<b>The HNTB Companies</b> Engineers Architects Planners	Made	<b>SJL</b>	Date	<b>6/20/2013</b>	Job Number <b>49633</b>
	Checked	<b>VWR</b>	Date	<b>6/21/2013</b>	
For <b>Cleveland Innerbelt</b>	Backchk'd	<b>SJL</b>	Date	<b>6/21/2013</b>	Sheet No.

## Unit 2 - Structural Steel, RFI 457

Girder 2, FS 31 and Girder 2 FS 66 (below FS 32) web splices have holes that conflict and need to be reamed to achieve fit-up in the field.

PROJECT Cleveland Innerbelt	MADE VWR	DATE 06-19-13	<b>HNTB</b>
STRUCTURE I-90 WB - Unit 2	CHECKED SJL	DATE 06-21-13	
FOR RFI 457 - FS 31, Girder 2	BACK CHECKED VWR	DATE 06-21-13	PROJECT NUMBER 49633

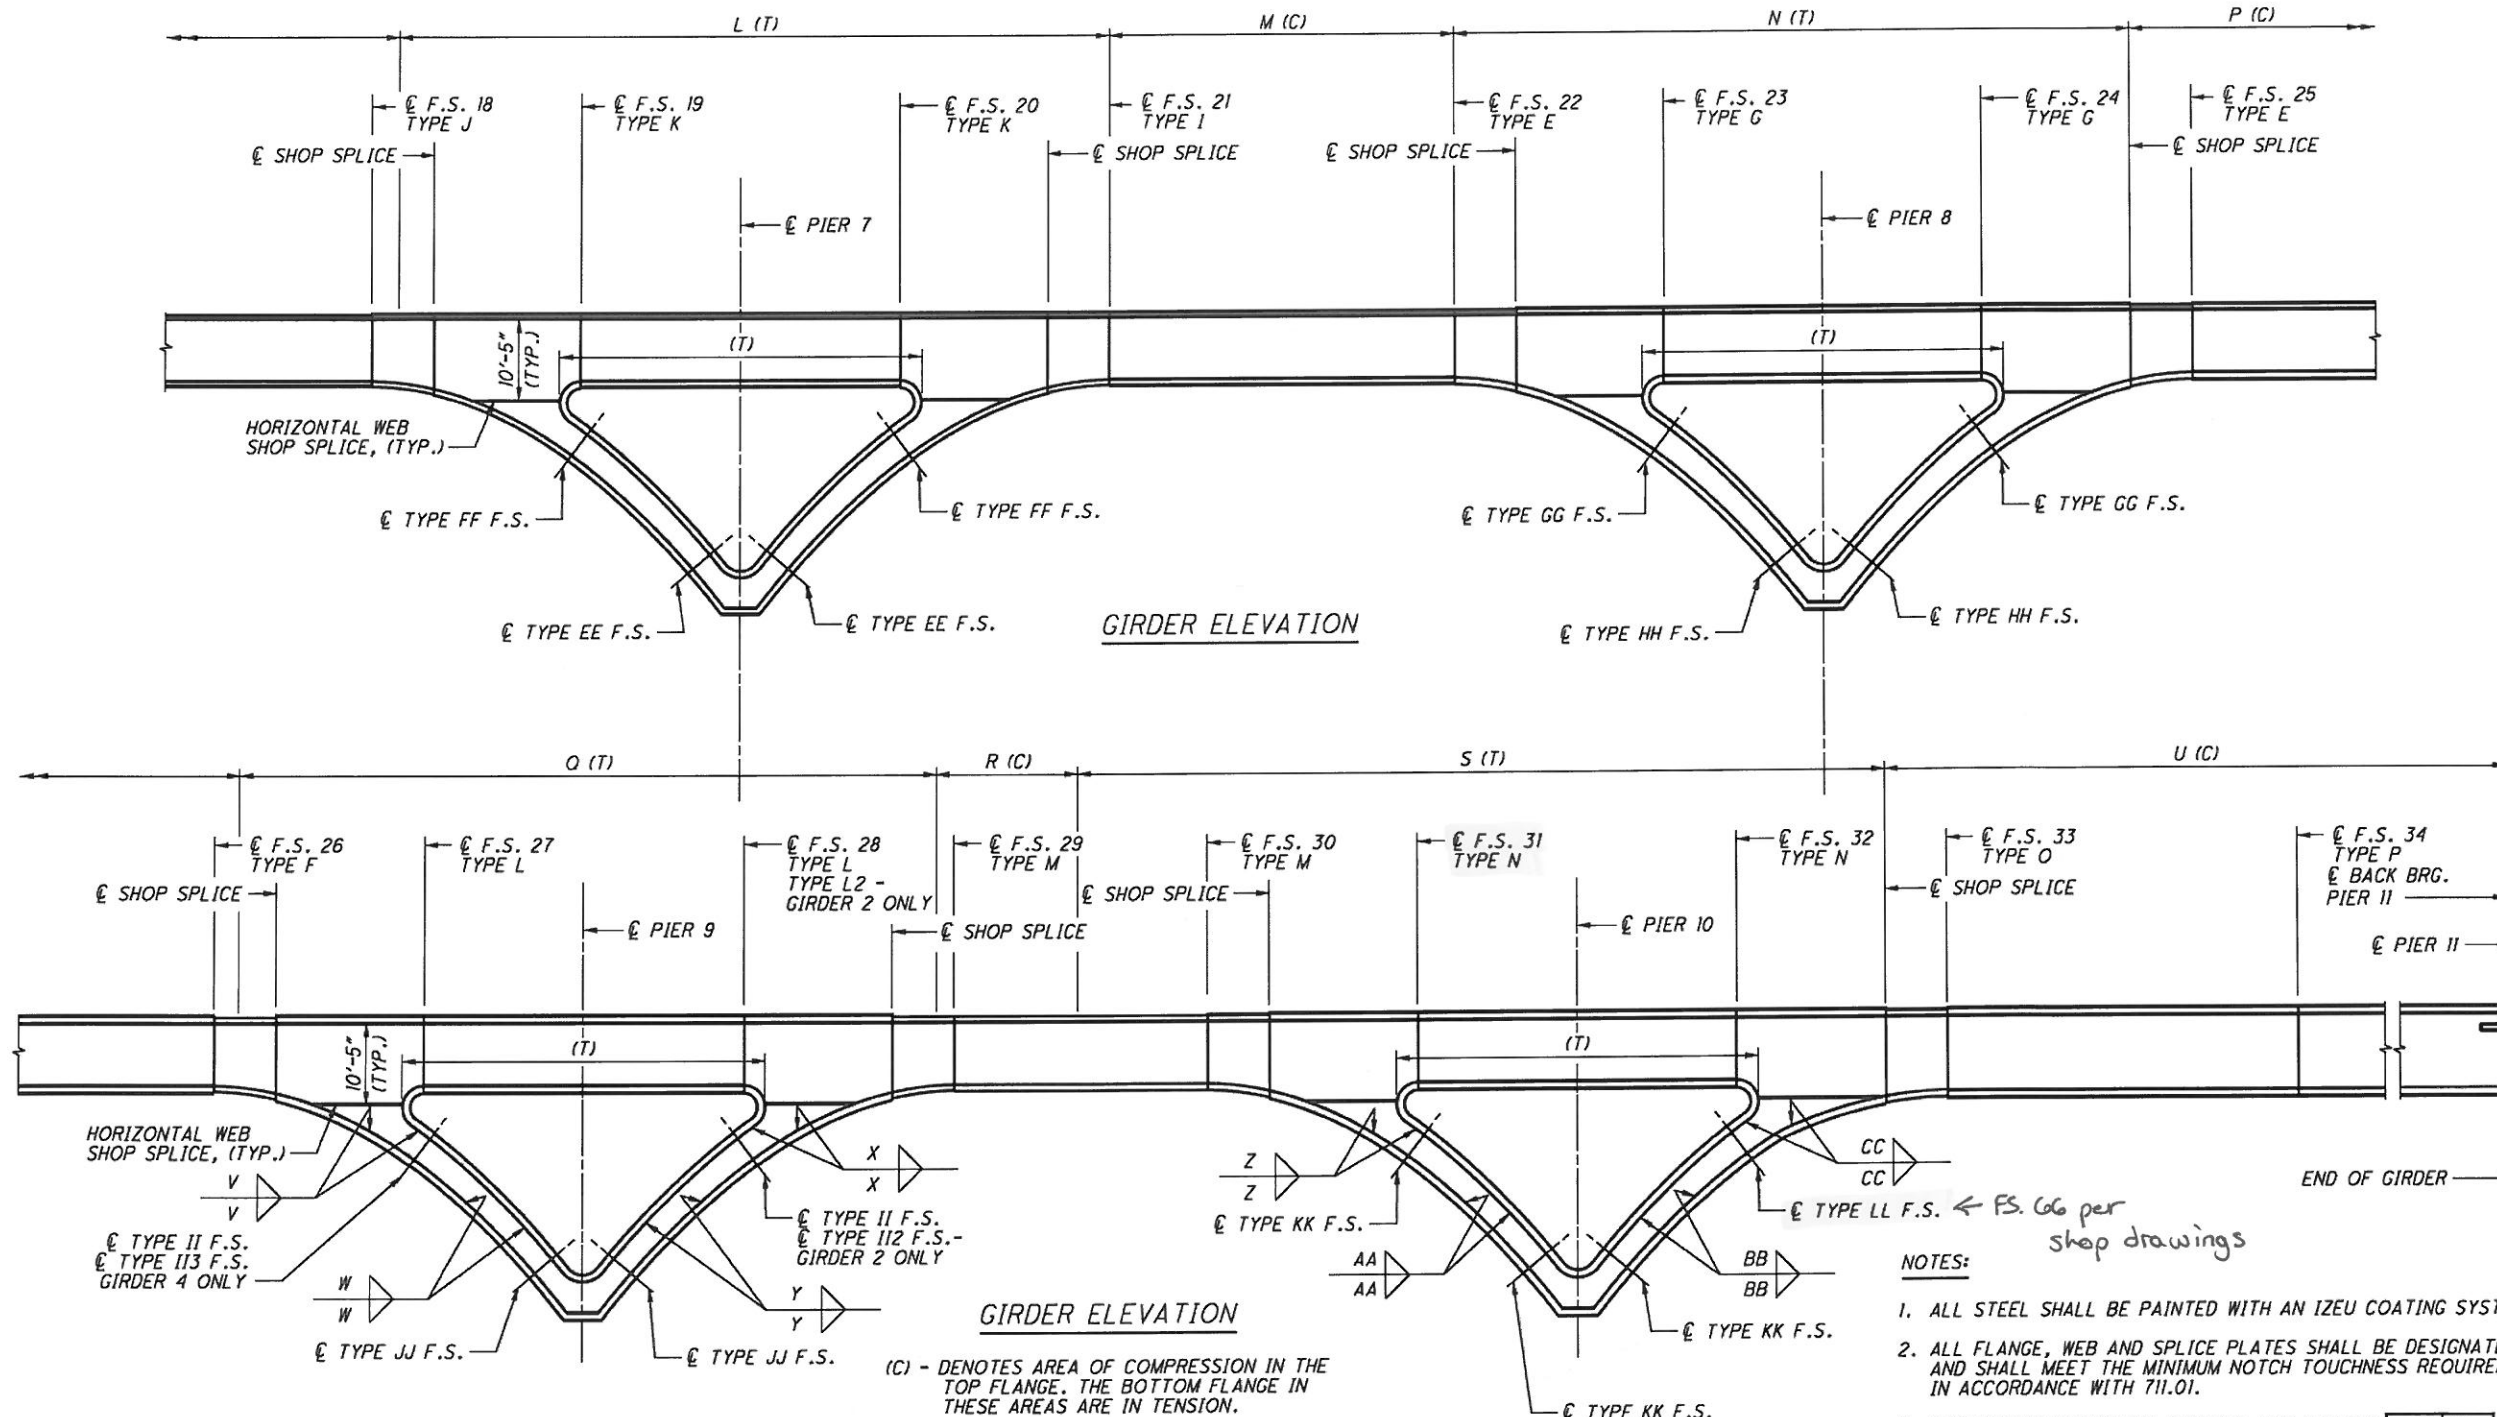
Walsh proposes to ream the conflicting holes to a 1.3125" dia. hole and use a 1.25" dia. bolt.

Calculations were performed to check the splices. Included in the calculations was the check for Bolt Bearing (AASHTO 6.13.2.9) with the reduced distance between holes and reduced end distances taken into account. Both Girder 2, FS 31 and Girder 2, FS 66 were found to be OK for design checks.

1. Flange splice not shown for clarity.
2. All material and workmanship shall be in accordance with the RFC plans.
3. The center of the reamed holes shall be shifted vertically 1/32" (up) and 3/32" horizontally (backstation) to allow conflicting material to be removed.
4. Bolts shall be high strength A325 galvanized Type I bolts.
5. Final reamed holes through splice plates and web shall be circular and concentric.
